ADDENDUM NO. 4

**BOONE GROVE HIGH SCHOOL
RENOVATION AND RELATED WORK
Valparaiso, IN 46341**

ADDENDUM FOUR

Addendum Four (AD.04) to the drawings and specifications prepared by Gibraltar Design for **Boone Grove HS Renovation and Related Work** for Porter Township School Corporation, Valparaiso, Indiana.

1
E-104

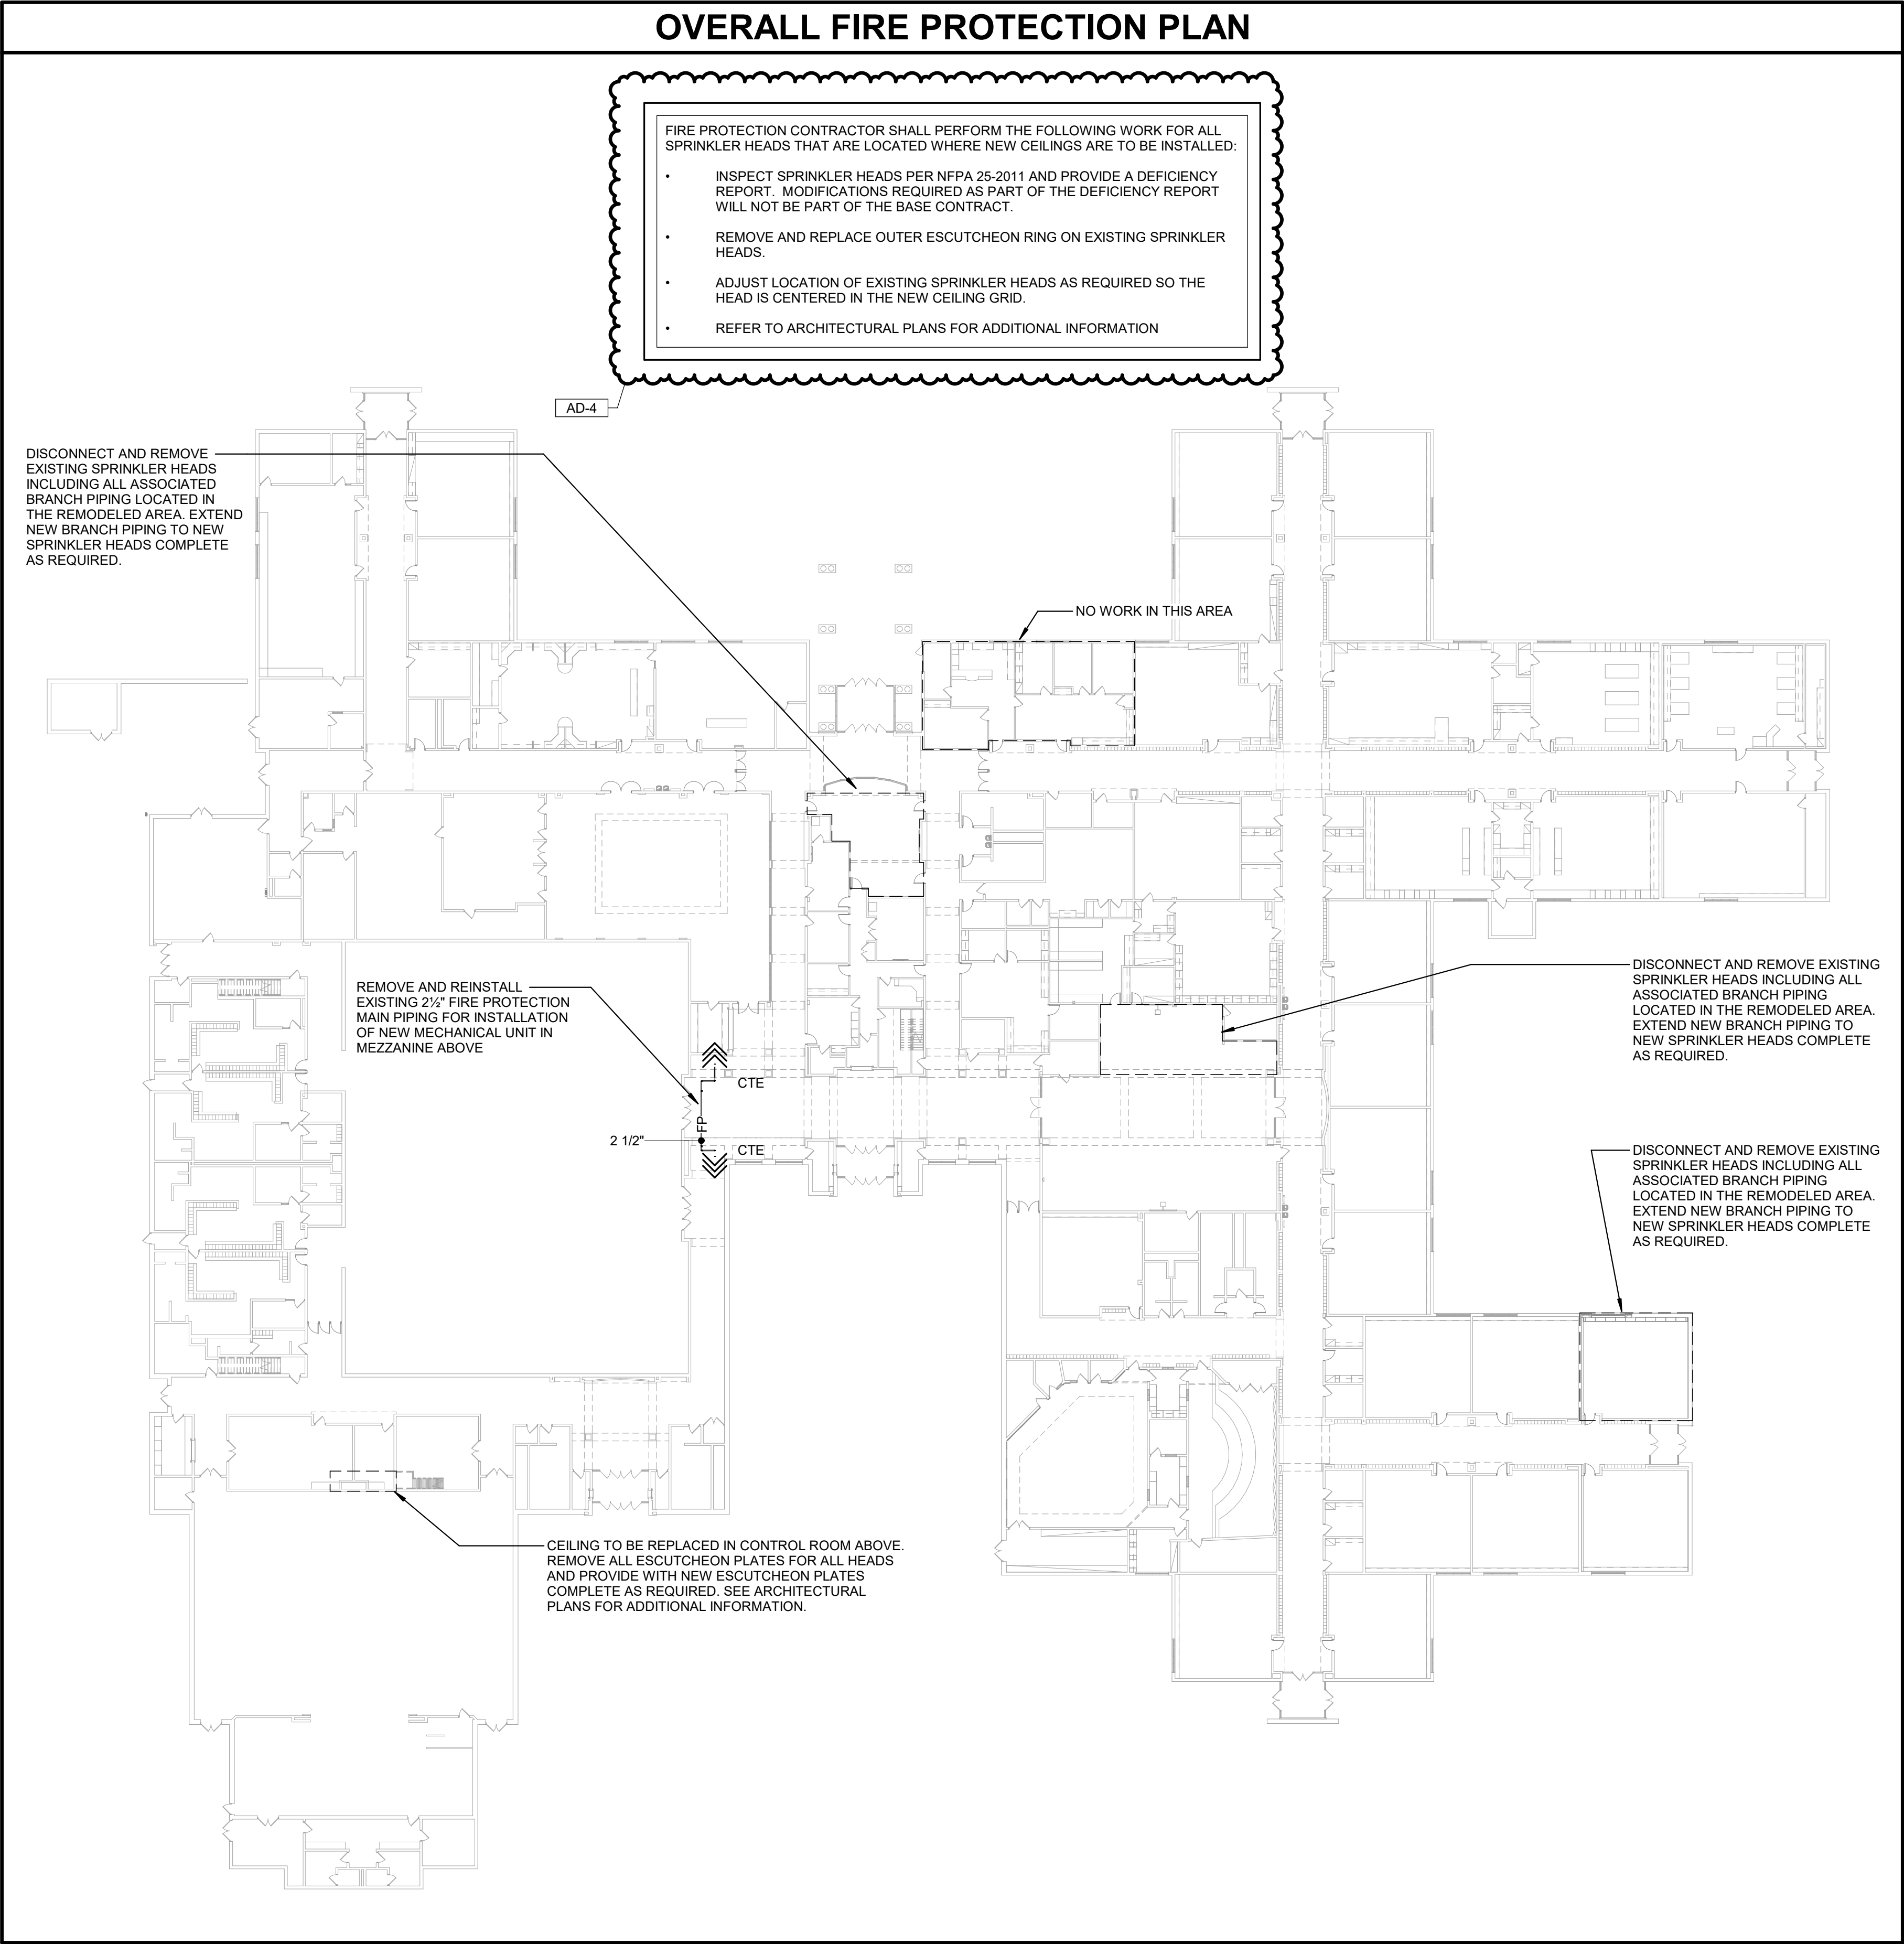
12. Sheets E-102 and E-104

- A. Refer to revised, full-size drawing, included in this Addendum, for revisions.
 - 1. Added new electromagnetic door-holds to requested locations.
 - 2. Added new locations for relocated items.
